Amendment Notice # 7

Licence Number	L8308/2008/2
Licence Holder	CITIC Pacific Mining Management Pty Ltd
ACN	119 578 371
File Number:	DER2014/000430-2~3
Premises	Sino Iron Project Mine Site Mining Tenements M08/123, M08/124, M08/125, M08/264, M08/265, M08/266, G08/54 and L08/126 MARDIE WA 6714
Date of Amendment	18/04/2019

The Licence Holder has submitted an application to amend licence L8308/2008/2 for a proposed raise 3 lift to TSF Stage 2 (TSF2).

Figure 1: Schematic Description of TSF Stage 2, Raises 1 - 3 (CITIC Application, 2019)

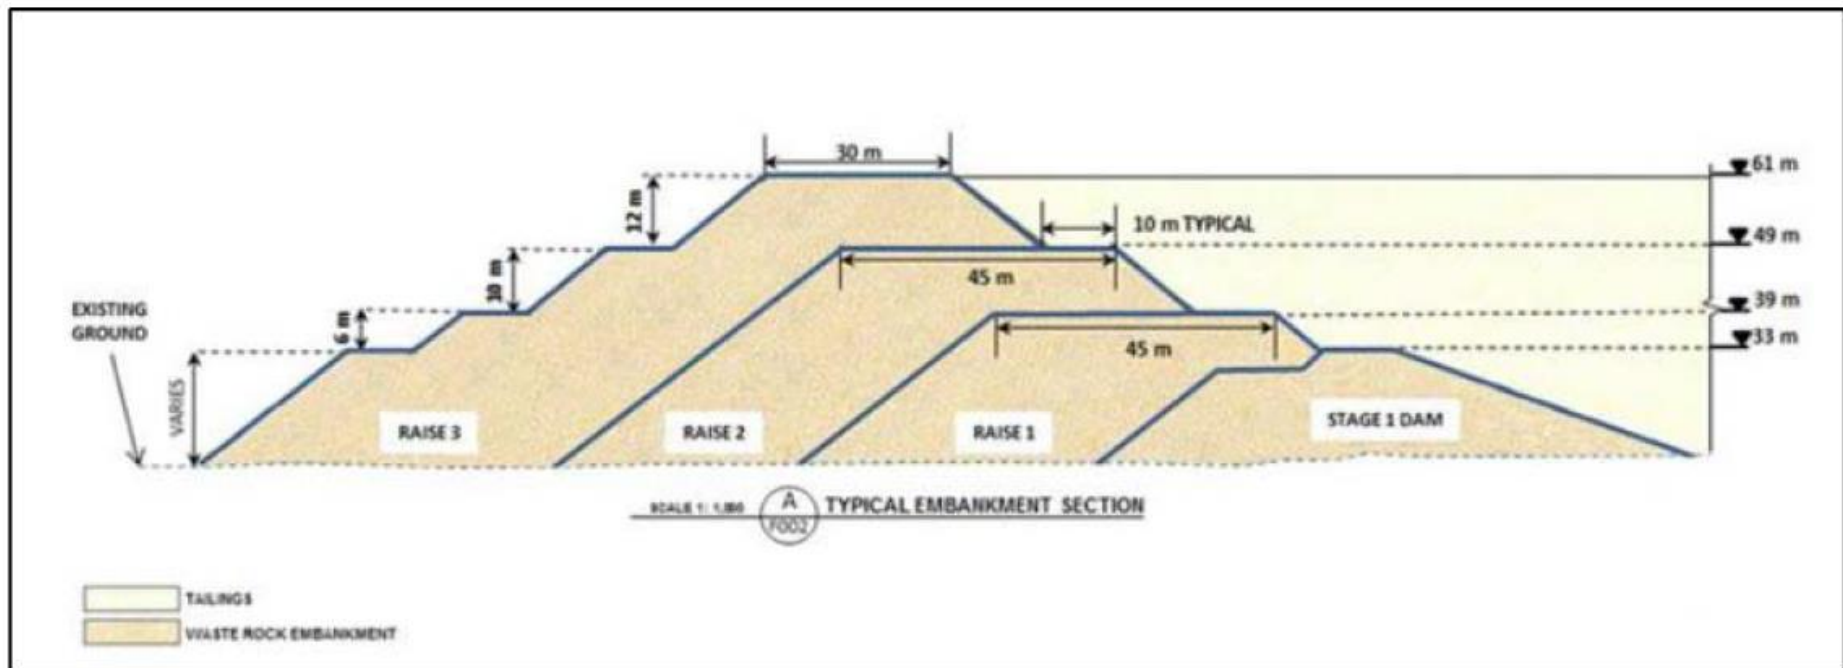
All facilities, including the required finger drains, seepage trenches, pumps and groundwater monitoring bores are already in place from current operations to support the proposed TSF2, Raise 3 lift. The TSF2 design report has been revised for the intended lifts.

It should be noted that TSF2 has been and continues to be constructed with steeper design angles on the walls due to tenure constraints. Low permeability zones have been included in the design of the northern and western embankments.

A linear low density polyethylene (LLDPE) geomembrane liner system was installed in TSF2 up to 39 mRL, however, due to the steeper design slopes for this next raise, an elastomeric bituminous geomembrane (BGM) is to be used as it has greater puncture resistance and does not require the same degree of surface preparation to install. The permeability of the BGM liner is approximately 4×10^{-14} m/s.

The Delegated Officer has determined that it is acceptable to include the TSF Stage 2, Raise 3 lift. All infrastructure to accommodate this is already in place (finger drains, seepage trenches and pumps and groundwater monitoring bores).

The maximum height of the TSF has been increased and the Elastomeric Bituminous Geomembrane Liner has been included for containment infrastructure requirements for Condition 1.2.8, Table 1.2.3.

Figure 5: Mine dewatering staging facilities layout plan (CITIC Design Drawings, 2019)

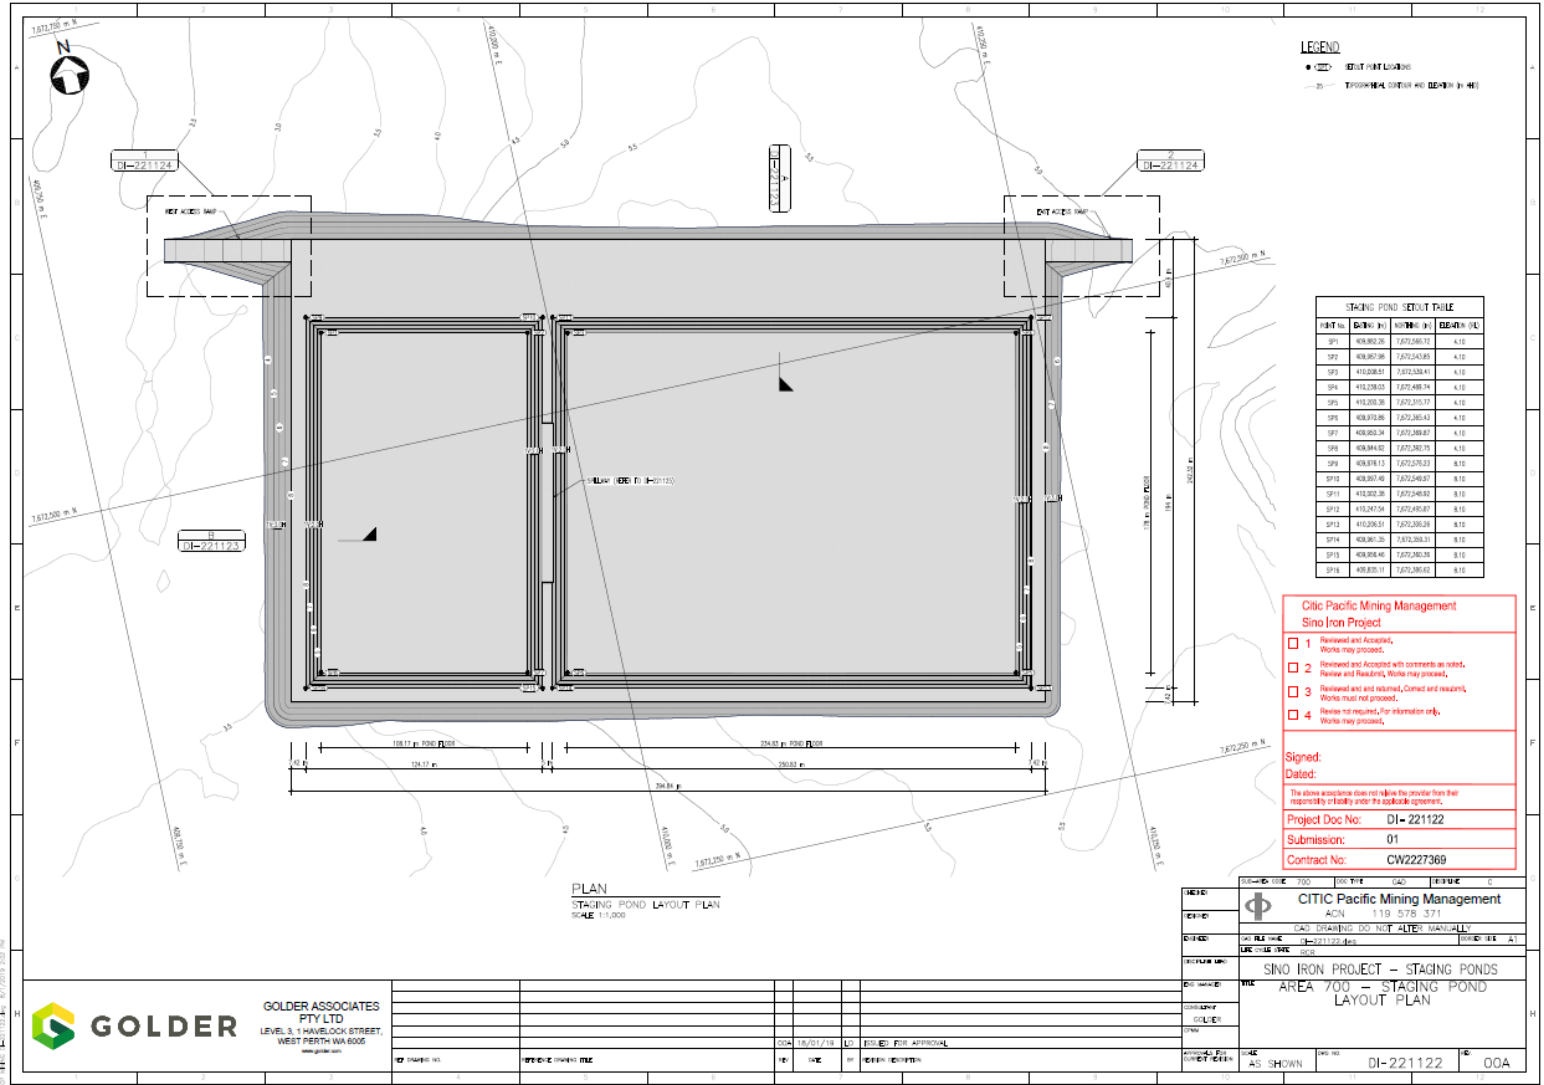
The Licence Holder is proposing to construct a dewatering staging facility to accommodate the increased (up to 12GL/annum) dewatering rates approved via MS1066 (s45C 18 July 2018). This will replace the existing dewatering staging ponds that are located within the boundary of the future mine pit. The new facility will allow temporary storage of excess mine dewatering water prior to reuse and/or discharge to the Fortescue River (FR2) or PMPL Algae Ponds (AP1).

This will be a single pond with two internal cells. The dimensions of the two cells are 124m x 194m & 250m x 194m with a combined storage capacity of ~0.3GL. The layout plan is shown in Figure 5.

The Delegated Officer has determined that the construction of a new staging facility is acceptable in the new location.

Containment infrastructure requirements have been updated in Condition 1.2.8, Table 1.2.3 to include the requirements for the staging facility.
